**BOARD OF ZONING ADJUSTMENT
STAFF REPORT****Date: May 1, 2017**

<u>CASE NUMBER</u>	6101
<u>APPLICANT NAME</u>	Pan American Engineers, LLC
<u>LOCATION</u>	Northeast corner of Airport Boulevard and North University Boulevard
<u>VARIANCE REQUEST</u>	SIGN: To allow two freestanding signs and four wall signs with one wall sign that exceeds 30% of usable wall area for a single business site in a B-2, Neighborhood Business District.
<u>ZONING ORDINANCE REQUIREMENT</u>	SIGN: The Zoning Ordinance allows only one freestanding sign and two wall signs for a single business site and wall signs not to exceed 30% of usable wall area in a B-2, Neighborhood Business District.
<u>ZONING</u>	B-2, Neighborhood Business District
<u>AREA OF PROPERTY</u>	48,800± square feet/1.12±Acres
<u>ENGINEERING COMMENTS</u>	No Comments
<u>TRAFFIC ENGINEERING COMMENTS</u>	No Comments
<u>URBAN FORESTRY COMMENTS</u>	Property to be developed in compliance with state and local laws that pertain to tree preservation and protection on both city and private properties (State Act 2015-116 and City Code Chapters 57 and 64).

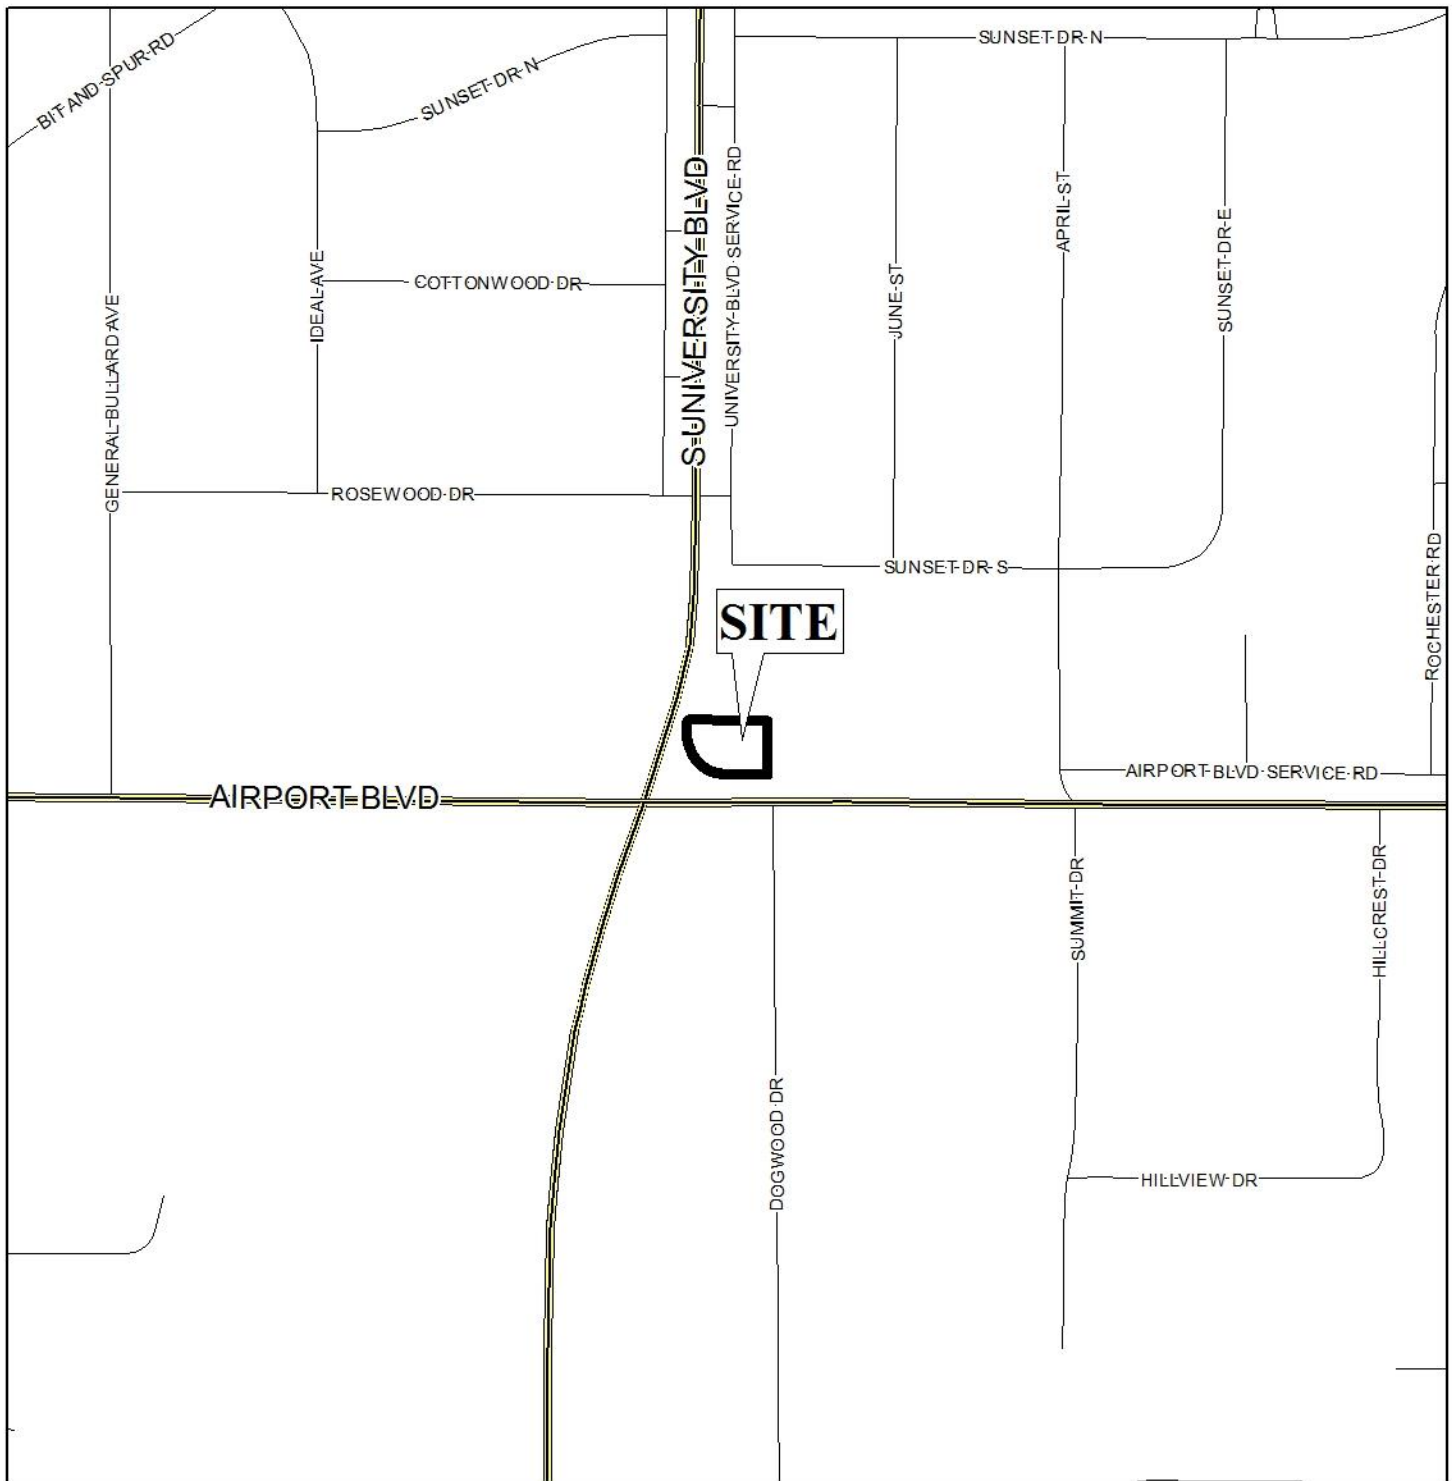
The applicant states that existing large trees, power poles, and traffic poles reduce visibility for signage at the location. While there are trees and power and utility poles in the area, none are of sufficient size or density to significantly impair visibility.

The applicant is requesting 4 wall signs to provide information regarding fuel prices to customers who are unable to see the proposed freestanding signs. As a single business site, the proposed business would be allowed two wall signs in addition to a freestanding sign. The applicant could place one of the signs on the East façade of the fuel canopy to provide visibility to customers at the adjacent Publix, and the other wall sign on a separate façade. The currently proposed wall sign on the East side of the fuel canopy appears to exceed 30% of the usable wall space, however

dimensions of the canopy were not clearly provided, so staff is unsure of the actual percentage of wall space the proposed sign would occupy.

The applicant has not clearly demonstrated a hardship exists at this location that necessitates additional signage. A single freestanding sign could be located at the corner of University Boulevard and Airport Boulevard with two appropriately sized wall signs placed as the applicant deems fit, to provide sufficient visibility of signage at the subject site. The applicant simply wishes to have more signage than the Zoning Ordinance allows, creating a self-imposed hardship.
